Project	IEEE 802.16 Broadband Wireless Access Working Group < http://ieee802.org/16 >	
Title	Proposed changes to Figure 3 of The Draft IEEE 802.16m System Description Document	
Date Submitted	2008-05-02	
Source(s)	Yair Bourlas, Lei Wang NextWave Wireless Inc.	Voice: E-mail: ybourlas@nextwave.com
Re:	Proposed changes to Figure 3 of SDD draft – Section 5	
Abstract	Changes to SDD Figure 3	
Purpose	Call for comments for IEEE 802.16m meeting in Macao	
Notice	<i>This document does not represent the agreed views of the IEEE 802.16 Working Group or any of its subgroups. It represents only the views of the participants listed in the “Source(s)” field above. It is offered as a basis for discussion. It is not binding on the contributor(s), who reserve(s) the right to add, amend or withdraw material contained herein.</i>	
Release	The contributor grants a free, irrevocable license to the IEEE to incorporate material contained in this contribution, and any modifications thereof, in the creation of an IEEE Standards publication; to copyright in the IEEE’s name any IEEE Standards publication even though it may include portions of this contribution; and at the IEEE’s sole discretion to permit other

Modified Figure 3 as shown below

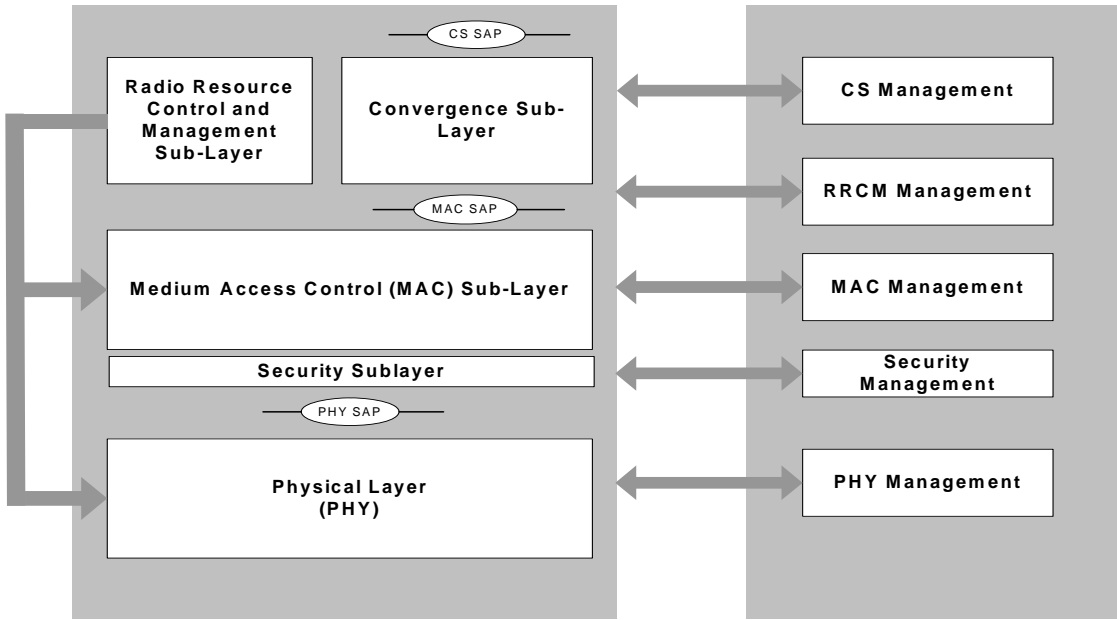
The contribution proposes a modified diagram for Figure 3 to reflect the partitioning of the MAC layer into three sub-layers.

- Convergence sub-layer (CS)
- Radio Resource Control and Management (RRCM) sub-Layer
- Medium Access Control (MAC) sub-Layer
